UNITED STATES PATENT AND TRADEMARK OFFICE

APPLICATION NO.	FILING DATE	FIRST NAMED INVENTOR	ATTORNEY DOCKET NO.	CONFIRMATION NO.
10/077,072	02/14/2002	Andreas Fischer	P0877	3504

Office Action Summary

FIG. 2
(Prior Art)

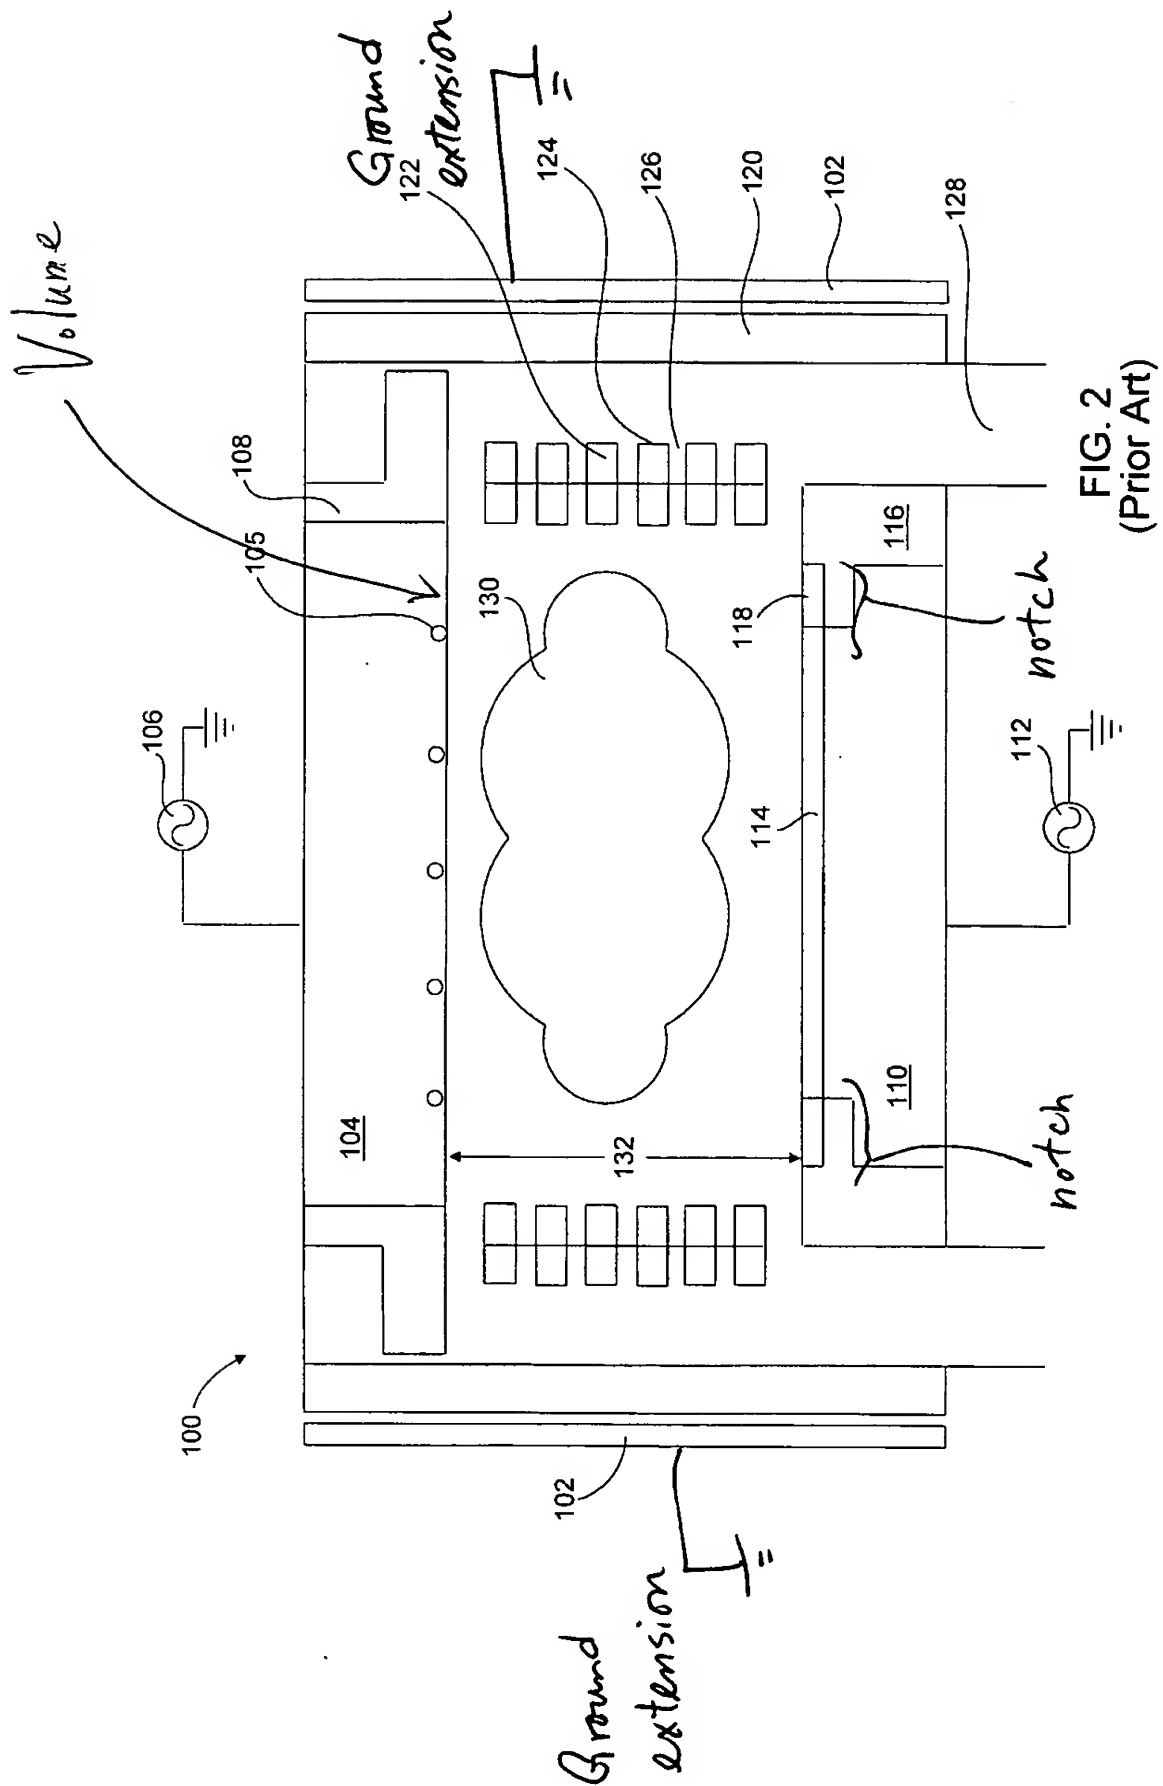
Regarding Claim 1, Li discloses a plasma processing chamber configured to generate a confined plasma (130) (See Figure 2 and Col. 4, lines 30-45), comprising:

- A plurality of confinement rings (124) surrounding a volume within which the confined plasma is substantially disposed (See Figure 2) (Col. 6, lines 1-5, show that the plasma is substantially confined and Abstract shows that the confinement rings is disposed so that the plasma generated therefrom will be disposed as well inside the chamber); and
- a ground extension (not shown in figure but shown in his teachings) adjacent said first powered electrode (110) and surrounding the first powered electrode (110) near the volume since Li teaches that the chamber wall (102) which surrounds the first electrode (110) can be coupled to ground (See attached Figure 2, Col. 2, lines 34-45 and Col. 4, lines 9-12).

Regarding Claim 2, Li discloses a confinement ring (122) configured to confine said plasma, the one confinement ring (122) surrounding said first powered electrode (110) (See Figure 2).

Regarding Claim 8, since Li discloses that the second electrode area (the under part of the second electrode 104) is greater than the first electrode area (the surface of the first electrode 110) (See Figure 2). Therefore, the electrode area ratio would be greater than 1.0 if the area ratio defined by dividing the second electrode area by the first electrode area.

Regarding Claim 9, Li discloses that the second electrode (110) further comprises a notch (labeled by examiner in attached Figure 2), the notch configured to increase said second electrode area (See attached Figure 2).

- A ground extension (not shown in figure but shown in his teachings) adjacent the first powered electrode (110) since Li teaches that the chamber wall (102) which surrounds the first electrode (110) can be coupled to ground (See Col. 4, lines 9-12) and surrounding the first powered electrode (110) near the volume confined by the plurality of confinement rings (124) (See Attached figure 2 labeled by examiner).

- engaging a power supply (112) to communicate RF power to the first electrode (110) to generate a plasma; and
- positioning a ground extension (not shown in figure but shown in his teachings) adjacent the first electrode (110) and near the volume defined by the plurality of confinement rings (124) (See attached figure 2) to drain a plurality of charge (electrons) from the

Regarding Claim 22, Li discloses that the ground extension is separated from the first powered electrode (110) by a dielectric (Teflon shroud 120. See Col. 2, line 25. See Attached Figure 2).

Li clearly discloses a volume (contained plasma) defined by confinement rings (See attached Figure 2).
